Intel[®] Mobile Pentium[®] II Processor Specification Update

Release Date: October 2000

Order Number: 243887-025

The Mobile Pentium[®] II processor may contain design defects or errors known as errata which may cause the product to deviate from published specifications. Current characterized errata are documented in this Specification Update.

Old Mobile Pentium® II Processor in Mini-Cartridge Package Label with Supplier Matrix Mark

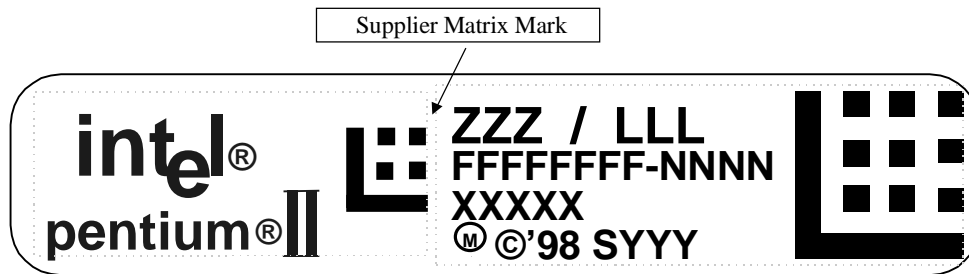
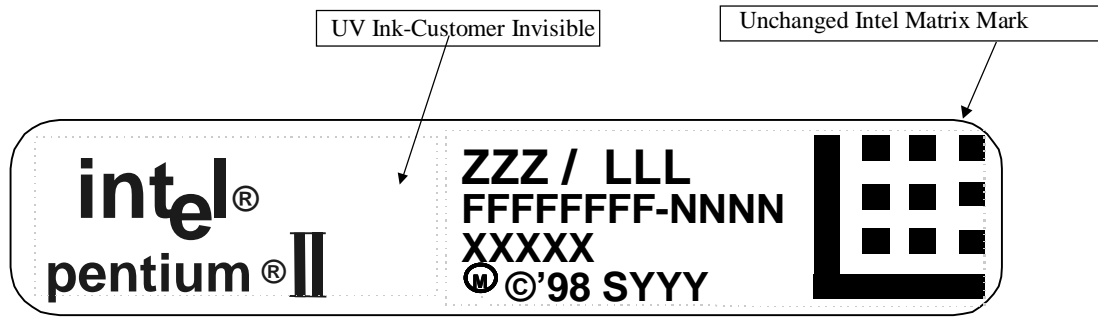
New Mobile Pentium® II Processor in Mini-Cartridge Package Label with Supplier Matrix Mark Removed

Figure 2. Workaround Flowchart: SMBALERT#-Driven System

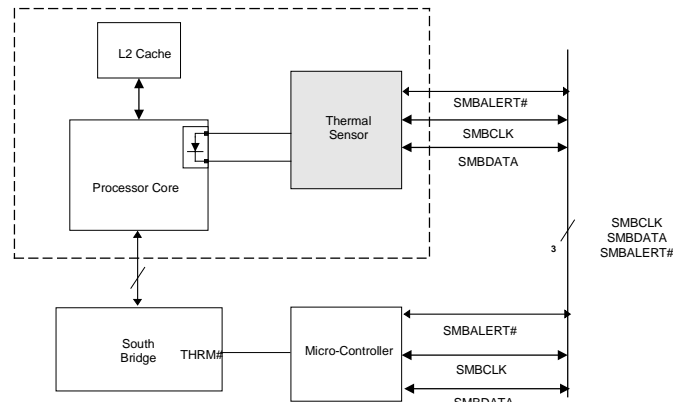
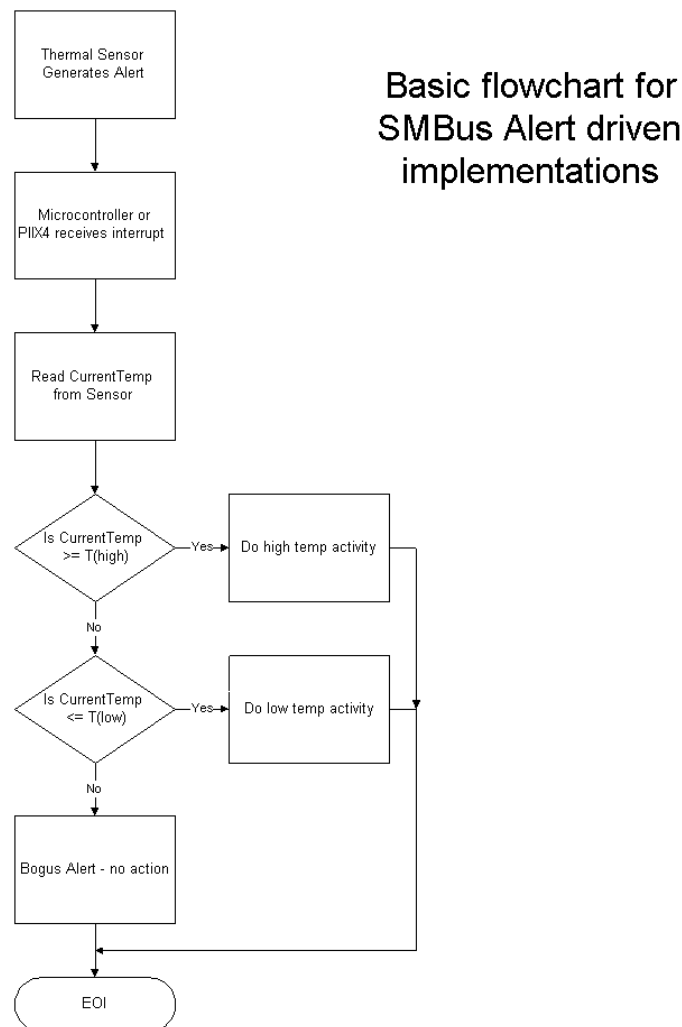
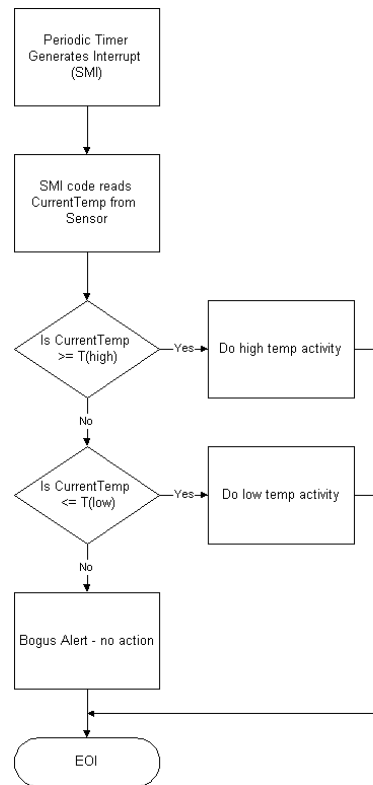
B30. Thermal Sensor May Assert SMBALERT# Incorrectly

Problem: The Mobile Pentium II processor and the Pentium II Processor Mobile Module have a thermal sensor that monitors the processor core's temperature. Please note that desktop systems could have a similar thermal device. The thermal sensor asserts SMBALERT# if the processor temperature exceeds the temperature limits set in the Alarm Threshold Registers (T_{HIGH} , T_{LOW}). It also sets the corresponding Status Register bits to identify the cause of the interrupt. Figure 1 gives one example of the how the SMBALERT# signal could be used in a system.

Under the conditions described below, the thermal sensor incorrectly generates the SMBALERT# interrupt. All of the following conditions must be met to trigger a false interrupt:

1. Before servicing an interrupt from the thermal sensor, read and compare the processor thermal reading with the threshold limits (T_{HIGH} or T_{LOW}). Figures 2 and 3 provide basic flowcharts for the implementation of this workaround in an interrupt driven system.
2. If the firmware implemented polls the Status Register only, then before taking any action, re-read the temperature register and do a comparison with the alarm threshold limits (T_{HIGH} or T_{LOW}) to determine if the value is actually still within the temperature window.

3. Use a temperature polling scheme to monitor the processor temperature.

Figure 5.6. Cross Sectional View with Vertical Dimensions

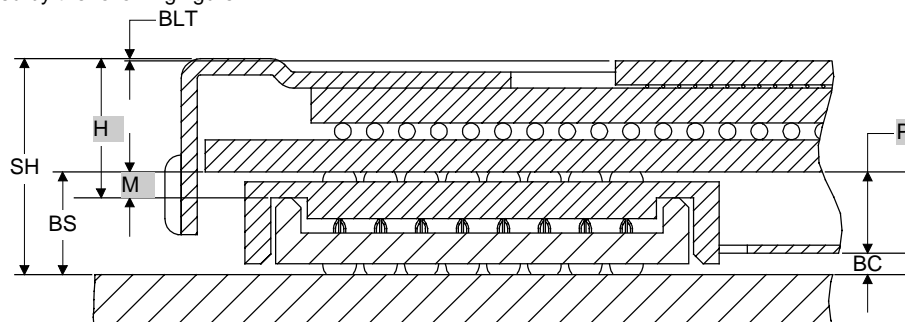
B1. Mislabeled Vertical Dimension Parameters

Figure 5.6 in the *Mobile Pentium® II Processor at 233 MHz, 266 MHz, and 300 MHz* datasheet should be replaced by the following figure:

Figure 5.3. Surface-Mount BGA1 Package—Top and Side View

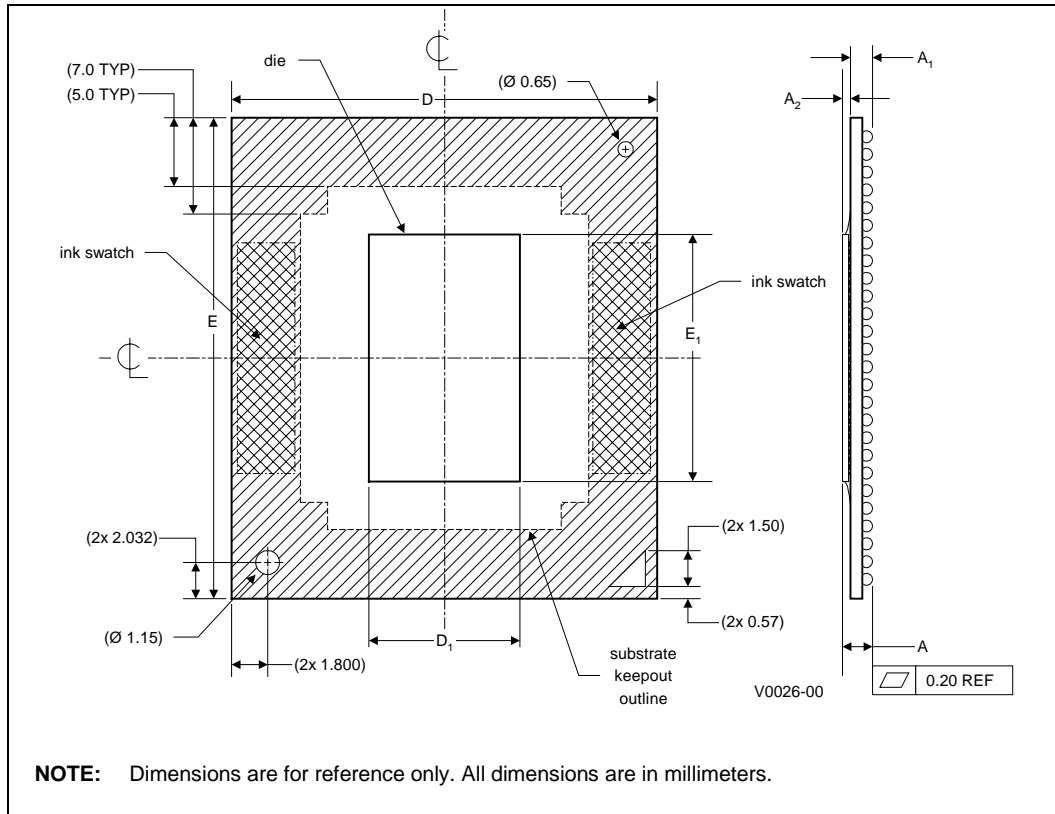
The following table and figures show the updated mechanical specifications for the BGA1 package, listed as Table 5.2, Figure 5.3 and Figure 5.4, respectively, in the *Mobile Pentium® II Processor in BGA Package at 366 MHz, 333 MHz, 300PE MHz, and 266PE MHz* datasheet.

Figure 3.3 Generic Clock Waveform

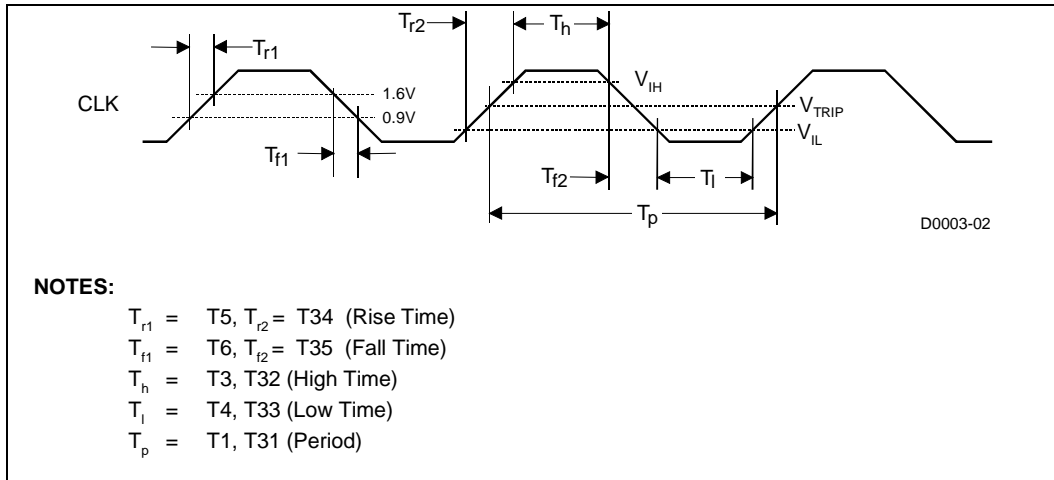
B14. Generic Clock Waveform Figure

Figure 3.3 in *Mobile Pentium® II Processor in Mini-Cartridge Package at 366 MHz, 333 MHz, 300PE MHz, and 266PE MHz* datasheet (Order Number 245108), and the *Mobile Pentium® II Processor in BGA Package at 366 MHz, 333 MHz, 300PE MHz, and 266PE MHz* datasheet (Order Number 245106) has been updated. The following figure is to replace the ones in the above documents.

Figure 1. TAP Gageable Thread Clarification

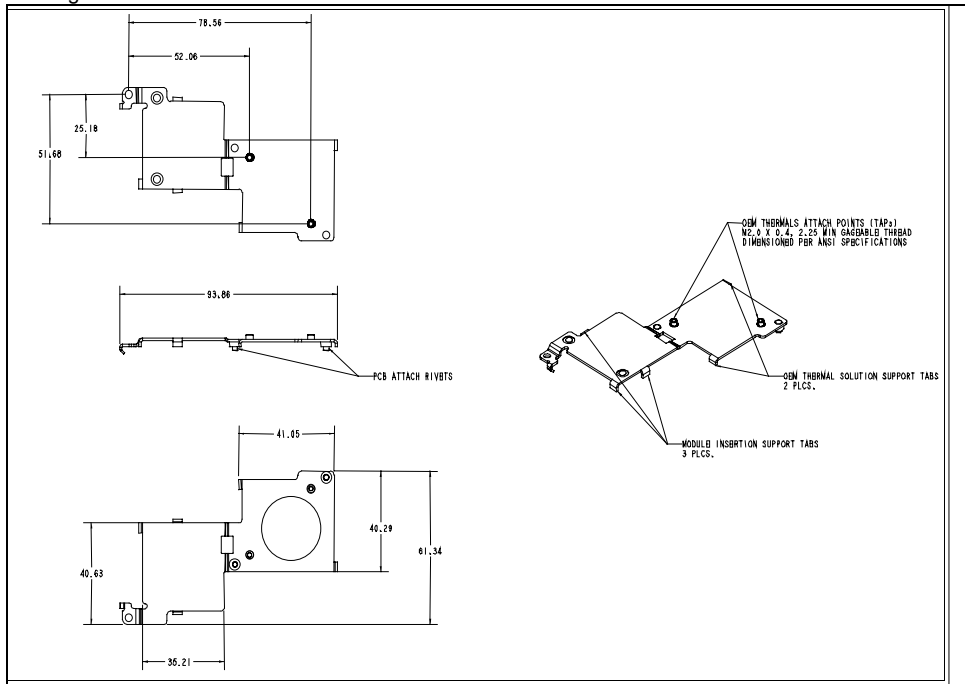
In the *Intel® Pentium® II Processor Mobile Module : Mobile Module Connector 1 (MMC-1)* and the *Intel® Pentium® II Processor Mobile Module : Mobile Module Connector 2 (MMC-2)* datasheets (Order Numbers 243667 and 243668, respectively), the thermal attach point (TAP) gageable thread specification was not clearly identified in Figure 14, of Section 5.2. The following is the TAP clarification:

OEM Thermal Attach Points (TAPs) M2.0 x 0.4, 2.25 min gageable thread dimensioned per ANSI specification.

See Figure 1 below for more information.
